MONTGOMERY COUNTY HISTORIC PRESERVATION COMMISSION
STAFF REPORT

Address:	3923 Prospect St., Kensington	Meeting Date:	11/12/2025
Resource:	Primary One Resource Kensington Historic District	Report Date:	11/5/2025
Applicant:	Helen Wilkes	Public Notice:	10/29/2025
Review:	Historic Area Work Permit	Tax Credit:	n/a
Permit Number:	1138162	Staff:	Dan Bruechert
PROPOSAL:	Tree Removal

Left to right: Tree #2 & #1, along left side of fence; Tree #3, on right side of fence

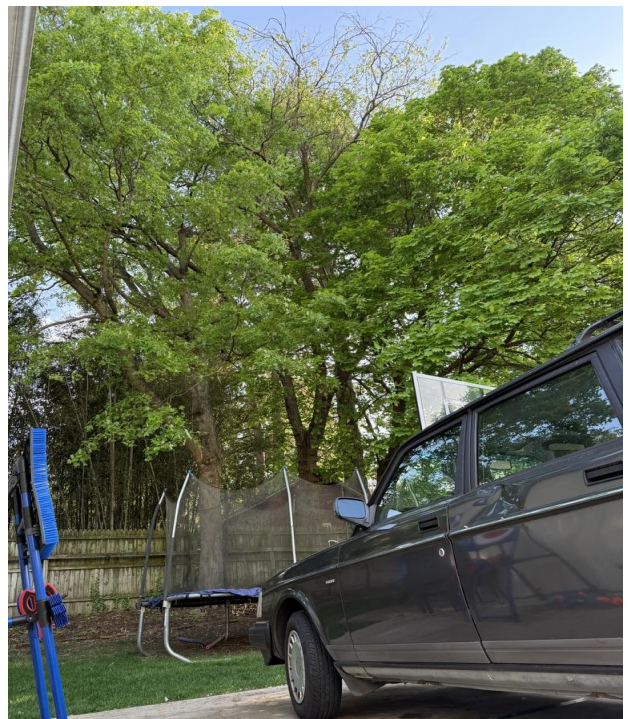
Trees #1 and #3 – Both of these trees are impacting the existing privacy fence at the rear of the property, but the larger rationale to remove these trees is that they are likely to be impacted by the construction of a garage that is anticipated at a future date. The health of both of these trees is good. Staff understands the desire to retain the existing fence and to remove all of the trees at the same time as a cost saving measure; however, Staff cannot base its recommendation on a potential future action (the construction of a garage).

Staff acknowledges that these two trees are at the rear of the property where they will have less impact on the district's overall tree canopy and recognizes the applicant's commitment to preserving the character of the Kensington Historic District; however, Staff does not find sufficient justification to recommend approval of these two trees without some measure of mitigation. The application states that the applicants would like to plant additional trees in the future, but Staff finds this speculative action is insufficient to make up for the loss of these trees.

Based on the trees modest size and their location at the rear of the property, Staff finds that removing trees #1 and #3 will not have a substantial impact on the overall character of the surrounding historic district. However, to support and promote the tree canopy that is a characteristic of the Kensington Historic District, Staff recommends the HPC add a condition to the approval of removing trees #1 and #3 that requires planting one hardwood canopy-species tree within twelve months each tree removed. With the recommended condition, Staff supports the removal of trees #1 and #3 under 24A-8(b)(2), the *Vision of Kensington*, and *Standard #2*.

Tree #2 – As noted in the application, the tree has significant deadwood in its crown and its roots are impacting an existing outbuilding. Staff additionally notes that Mulberries are an invasive species. Staff finds its removal will protect the foundation of the existing accessory structure and due to its location at the rear of the property, its removal will not substantially impact the mature tree canopy that is characteristic of the Kensington Historic District. Staff recommends approval under 24A-8(b)(2) and (4) and *Standard #2*.

1. One hardwood canopy species tree must be planted on the subject lots within twelve months to mitigate the removal of trees #1 and #3. A site plan identifying the location and species of proposed trees must be submitted to Staff prior to issuance of the HAWP approval.;
- under the Criteria for Issuance in Chapter 24A-8(b)(2) having found that the proposal, is consistent with the *Vision of Kensington*, and therefore will not substantially alter the exterior features of the historic resource and is compatible in character with the district and the purposes of Chapter 24A;

Tree #4, situated at rear of 3924 Baltimore, is intruding into, and collapsing, the old stone wall of the compost pile at the rear of 3923 Prospect St.

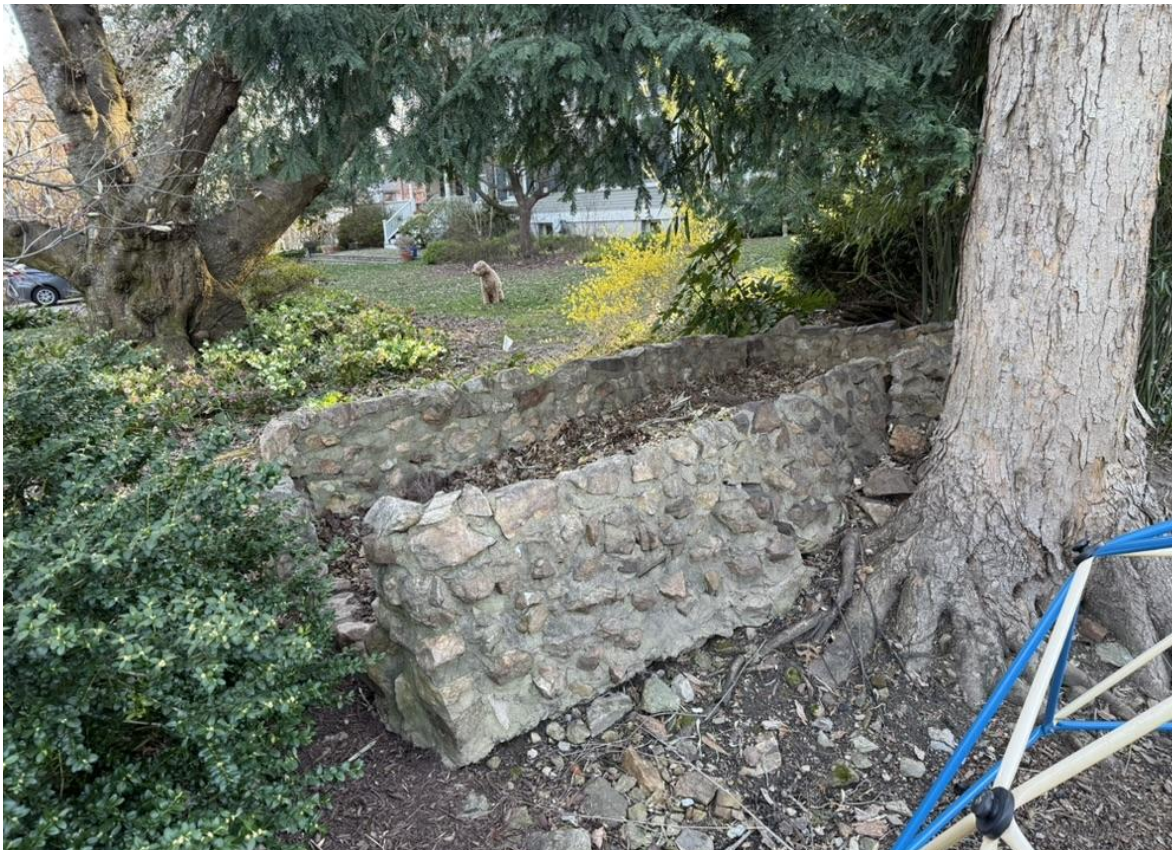
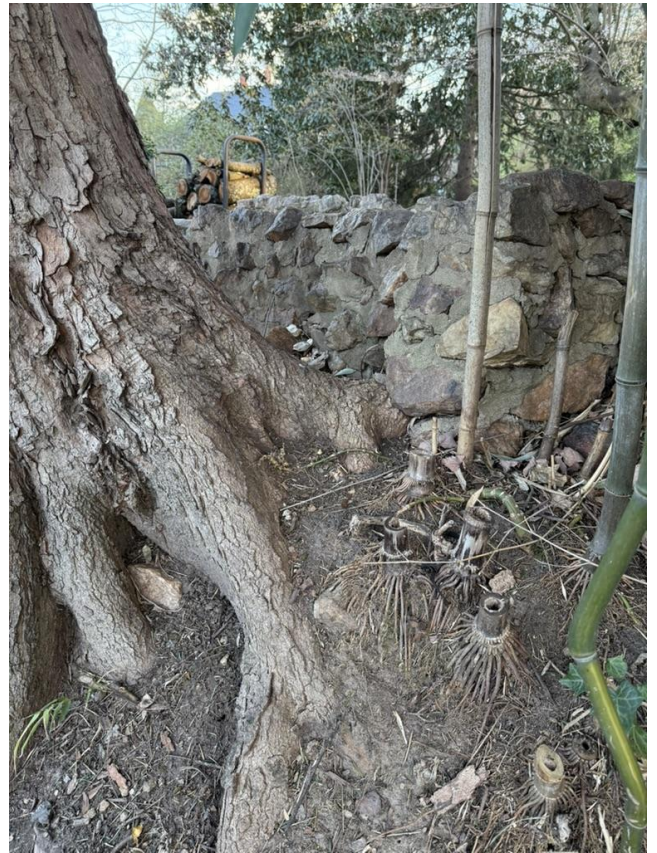
Tree #4 – The application indicates that this tree is damaging a garden compost structure the application refers to as "historic" in the rear of the property. While Staff was unable to find any documentation of this structure prior to a 1998 HAWP application, based on the fieldstone and concrete construction method and overall material condition, Staff finds this landscape feature is generally consistent with late

19th or early 20th century construction; however, the feature should not be considered character-defining for the site nor should the disposition of the garden structure dictate whether or not the tree should be removed. The proposal is to remove this tree and repair the structure. Staff supports the removal of this maple tree in the rear yard. Staff recommends approval under 24A-8(b)(2) and (4) and *Standard #2*.

Tree #5 – This tree is constructed immediately adjacent to an outbuilding and is leaning next to the existing accessory structure. This accessory structure was originally associated with 3920 Baltimore St. but was relocated from its historic location when the HPC approved the construction of the 3922 Baltimore St. in 2000.¹ Staff is unsure of the exact date of construction of this accessory structure, but notes it is shown on the 1924 Sanborn Fire Insurance Map of Kensington. Staff finds that the root system of this tree will likely damage the foundation of the historic outbuilding and its removal is necessary to protect the resource. Staff recommends approval under 24A-8(b)(2) and (4) and *Standard #2*.
